-ADDENDUM NUMBER 2

May 2, 2023

PROJECT:
CITY OF MOBILE PARK IMPROVEMENTS

GMC PROJECT NO. AMOB220095

CB416
CABINET DETAILS

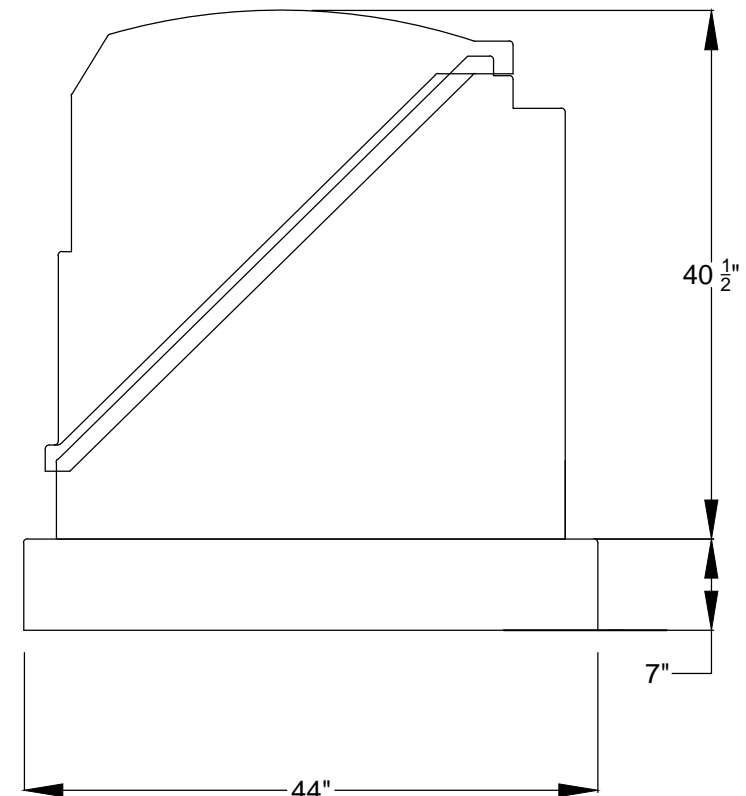
1. Added CB416 Cabinet Details to Addendum #2 for Baumhauer splash pad equipment.
